City of Parramatta	
File No:	DA/837/2022

SECTION 4.15 ASSESSMENT REPORT

DA No:	DA/837/2022
Property:	Lot A DP 375159, 183 Macquarie Street, PARRAMATTA NSW 2150
Proposal:	Construction of a 12 storey building containing a retail shop and a 'Co-Living' development comprising 93 rooms with indoor and outdoor communal spaces over 1 level of basement.
Date of receipt:	25 October 2022
Applicant:	PTI Architecture
Owner:	Rapisarda Holding Pty Limited
Is the property known to be owned by a Council employee or Councillor?	No
Political donations/gifts disclosed:	None disclosed on the application form
Submissions received:	8 submissions
Conciliation Conference Held:	No
Recommendation:	Refusal
Responsible Officer:	Paul Sartor

Figure 8 Screenshot of plans for 189 Macquarie St showing proposed tower setbacks to 183 Macquarie St (Source: CDA Architects, 2022)

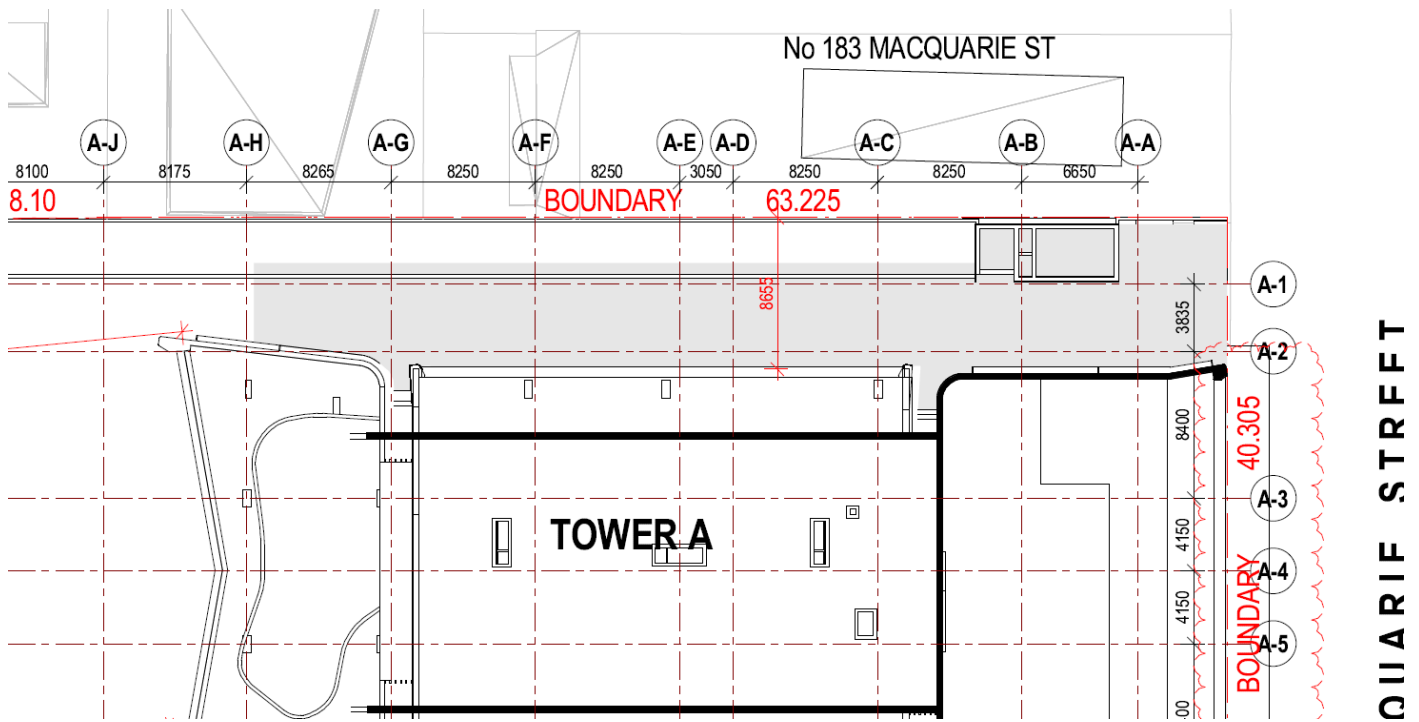
An approval has been granted for a 47 storey multi tower development above the carpark. The tower for this site has an 8.6m setback to the boundary, which, whilst not quite the required 9m-12m shared ADG setback, is considered acceptable for a CBD setting. .

The proposed development provides a zero lot setback with the exception of a small void that is 3m deep. This removes any opportunity for windows at the boundary and cross ventilation which will provide a sustainable design practice that will reduce the requirement for air conditioning and increase natural light to the rooms that only face the void. This again is due to the site size.

Figure 9 - Site map showing adjoining lot, highlighted in yellow

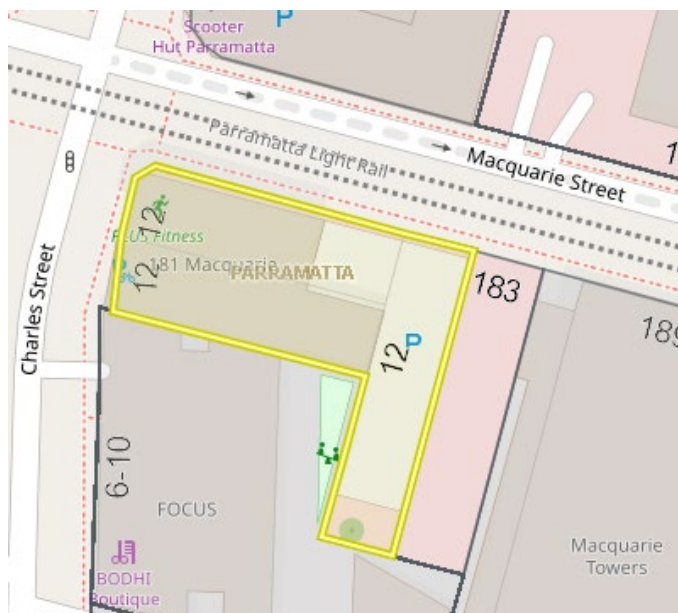
The adjoining site contains a two-storey commercial building and an at grade carpark, there are no plans for the redevelopment of this site at this time. Under PLEP 2023, and noting the size of the site, there is a development potential of 7.6:1FSR with a 145m height limit. The subject DA proposes a 12-storey blank wall on the boundary on the western elevation. Zero lot setbacks are acceptable in the CBD in circumstances where there are adjoining podiums.
